**FINAL DRAINAGE REPORT**  
for  
**FALCON MARKETPLACE**

El Paso County, Colorado

**December 21, 2018**

**SF-19-001**

**PROPOSED DRAINAGE CONDITIONS**  
 PROJECT NO. 20988--00CSCV  
 DRAWING NO.

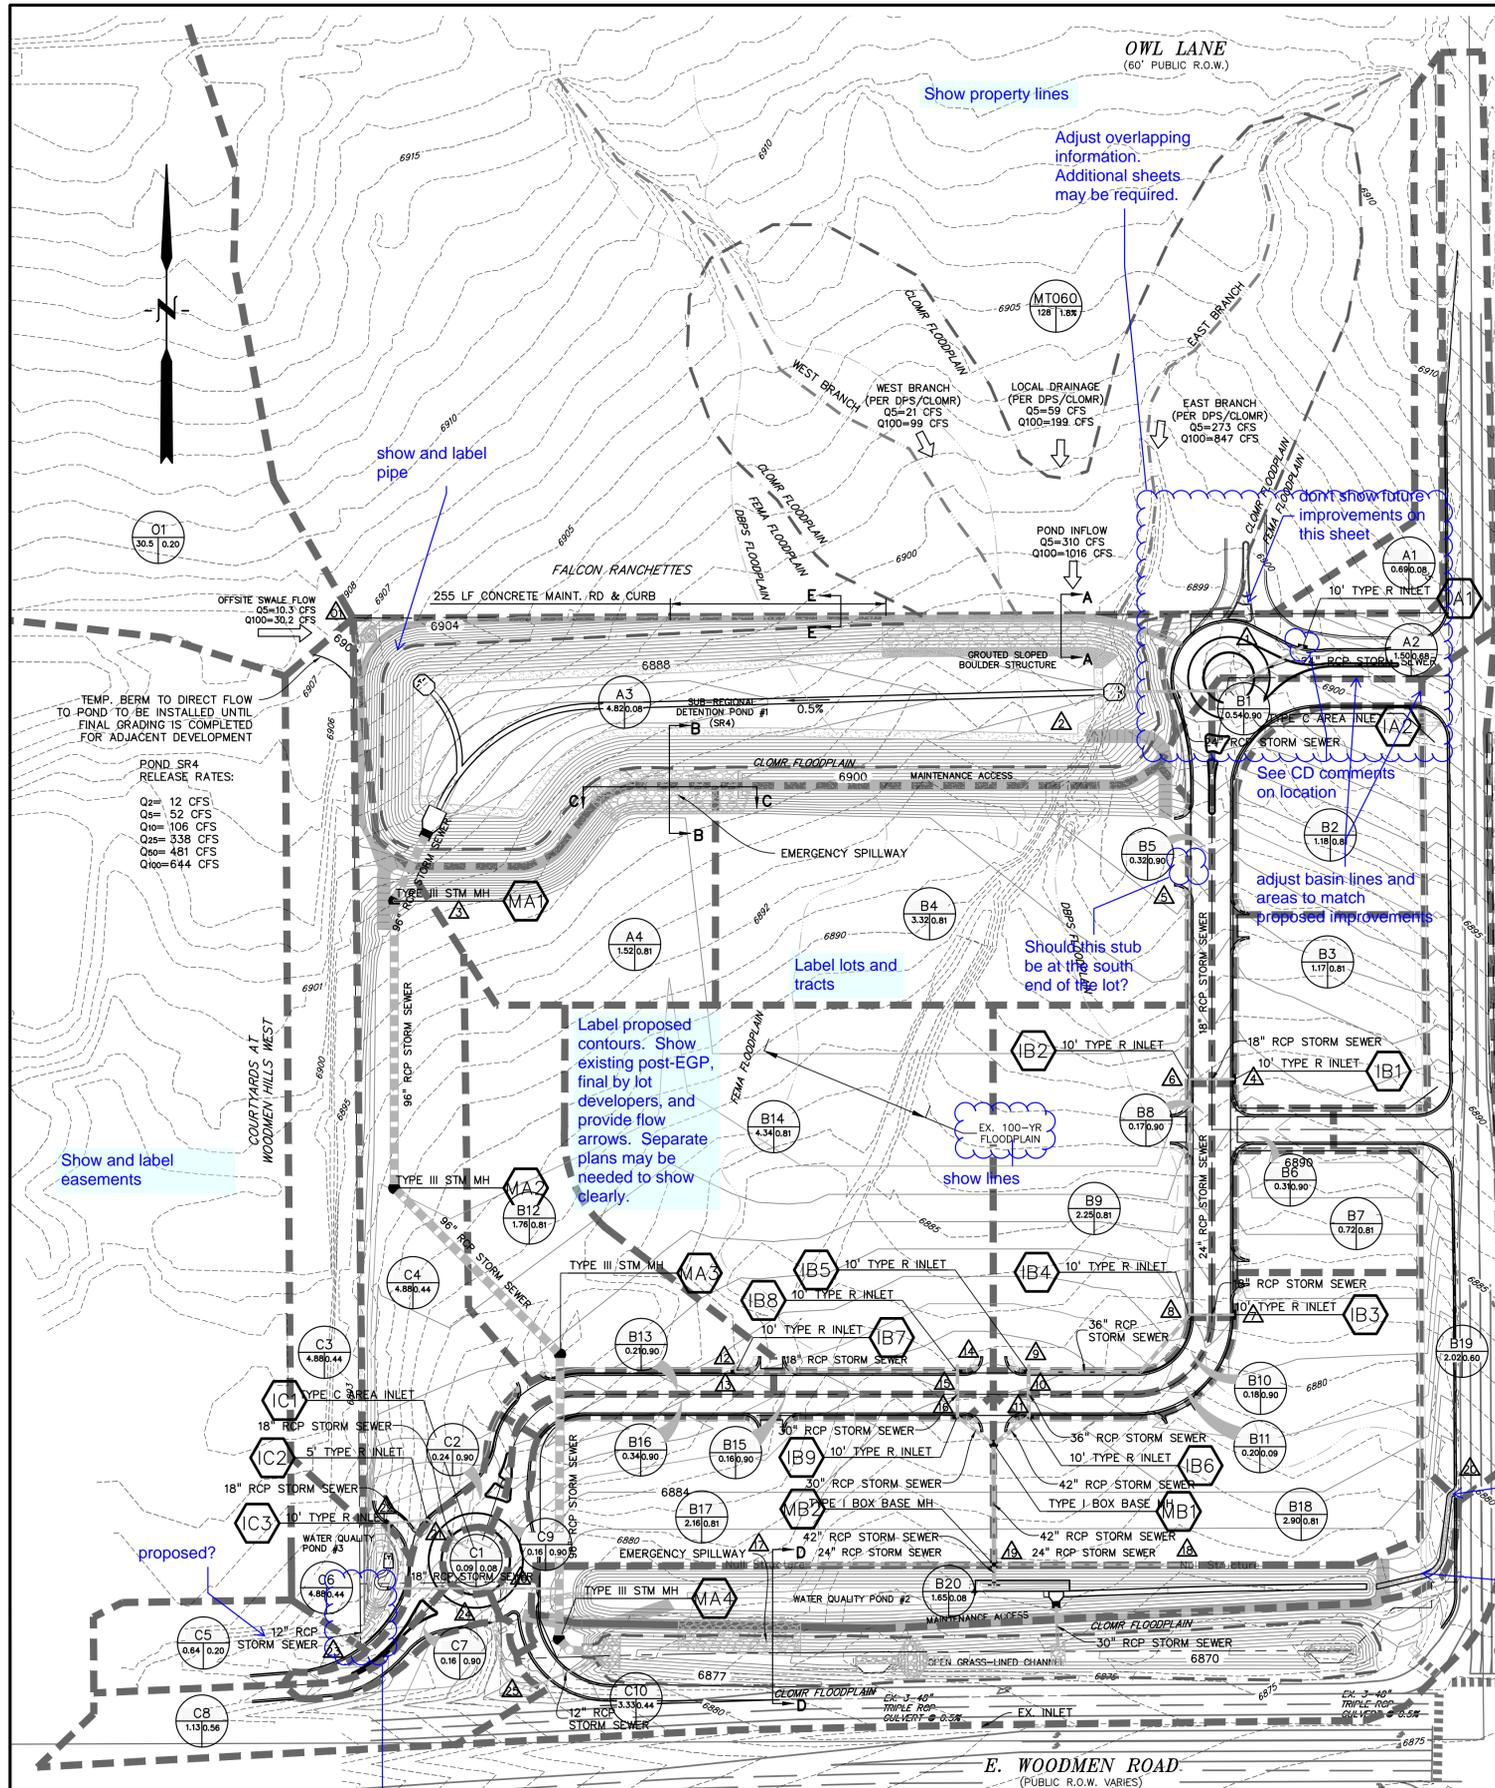
Label type of crossing, provide detail

Label, provide detail

provide details

clearly show proposed grading.

Address capacity, increased flow, show outfall pipes.

show lines

don't show future improvements on this sheet

Show property lines

provide labels

provide details and forebay
